Product Change Notice

Date:	February 26, 2020
Overview:	Change to the shrink tubing procedure for (7) AC blowers – instead of shrinking the entire length of the tubing, going forward only a portion of the tubing will be shrunk
Reason for Change:	In rare cases, shrinking the tubing over the entire length of the wires may exert enough pressure on the wire insulation to pull back slightly from the brass-lead tip ends, leaving a small area of exposed wires at the lead wire ends. By not shrinking the tubing at the end of the lead wires it will eliminate this potential scenario that may occur on our production line.
Affected Part No(s):	<ul style="list-style-type: none"> - G2E180-EH03-17 - R2E250-RB06-12 - R2E250-RB06-19 - R2E250-RB06-33 - R2E250-RC08-16 - R4E310-AO12-14 - R4E310-AO32-13
Design Change Detail:	<p>Currently the tubing is heat-shrunk for the entire length of the cable.</p> <p>Moving forward the tubing will be heat-shrunk for only about a 60 mm distance from the stator / motor, after which the tubing will remain loose.</p>

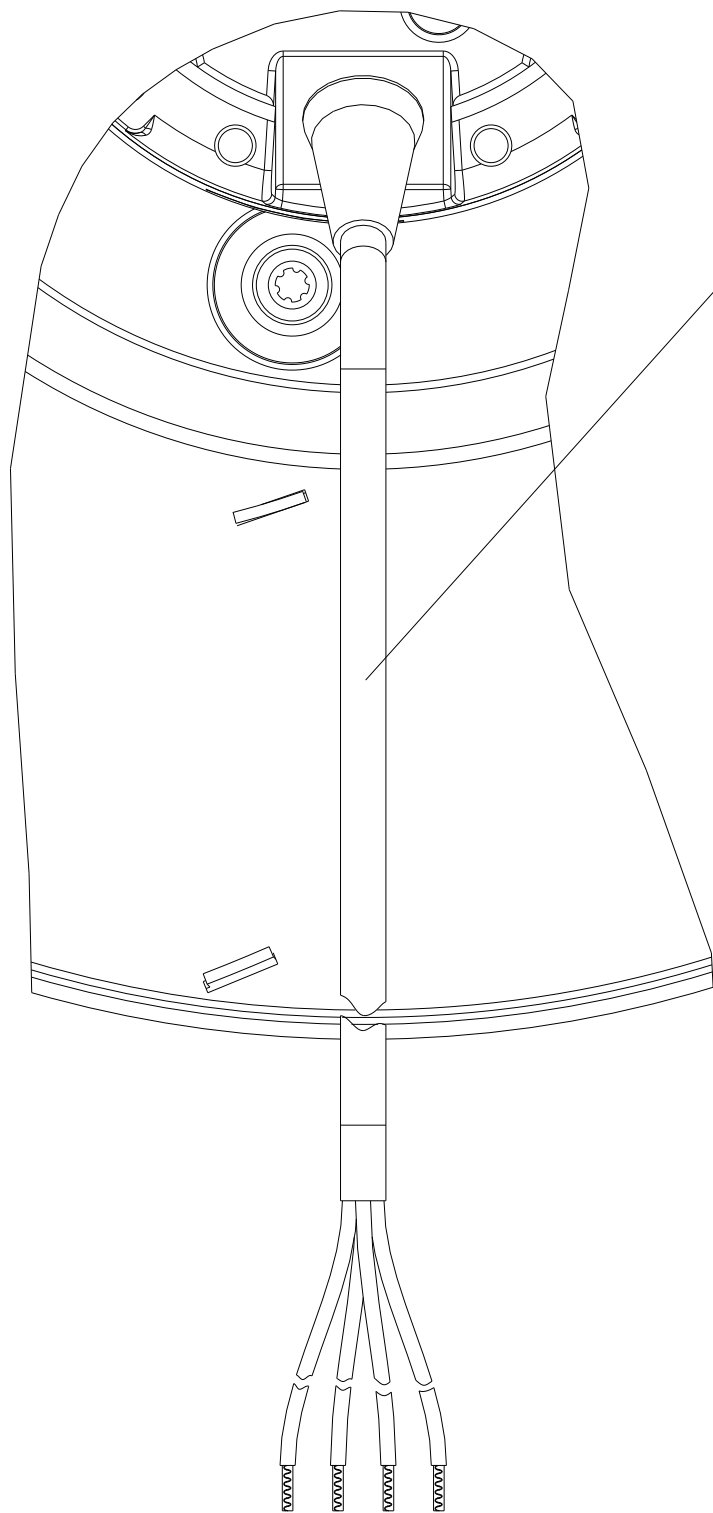
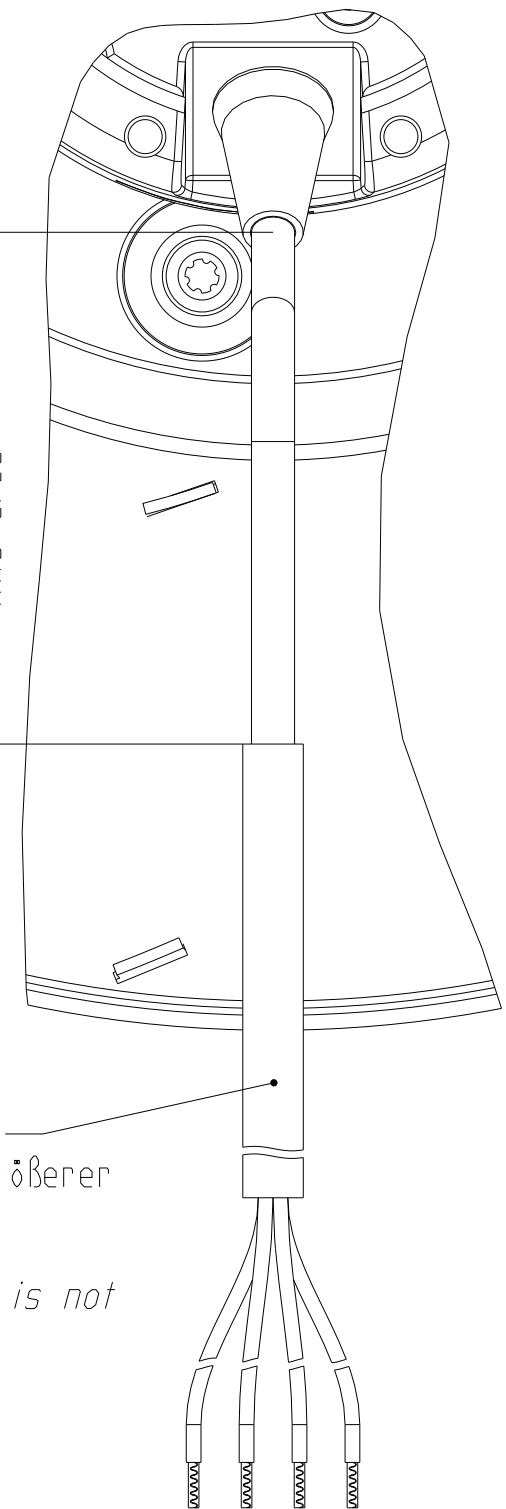
bisherige Ausführung:
Schrumpfschlauch komplett
geschrumpft
*existing design:
shrink-sleeve completely shrunk*

ca. 60
in diesem Bereich
geschrumpft
*approx. 60-
heat-shrunk in
this area*

der restliche Schrumpfschlauch
bleibt ungeschrumpft, somit größerer
Durchmesser
*new design:
the rest of the shrink-sleeve is not
shrunk, thus larger diameter*
